Internal Memo

Planning Application: **1 Vulcan Buildings, Brecon Road, Merthyr Tydfil.**

Proposal: Partial change of use of ground floor from residential (C3 Use Class) to takeaway (A3 Use Class) and installation of flue to rear elevation and new shop front to front elevation.

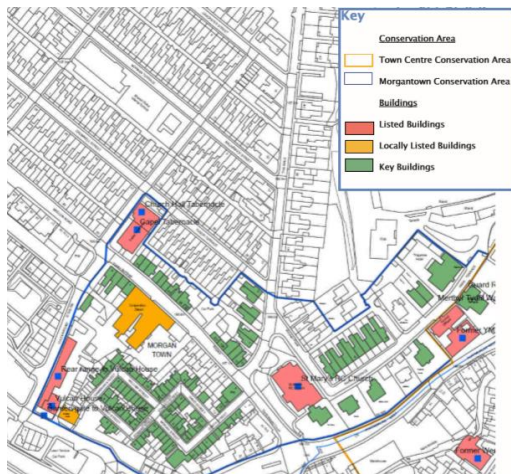
The existing building retains the last double window roof dormer with decorative barge board on the front elevation within the short block of four buildings. The chimneys, projecting bay window below the roof dormer, along with the ground floor window and door have been altered on the front elevation and a formally modest dormer on the rear of the elevation has been increased to fill the roof scape.

The alterations have taken place prior to the designation of the conservation area and the above photograph gives an indication of original proportions. The rear of the building is poorly altered and lacks visual and symmetrical balance.
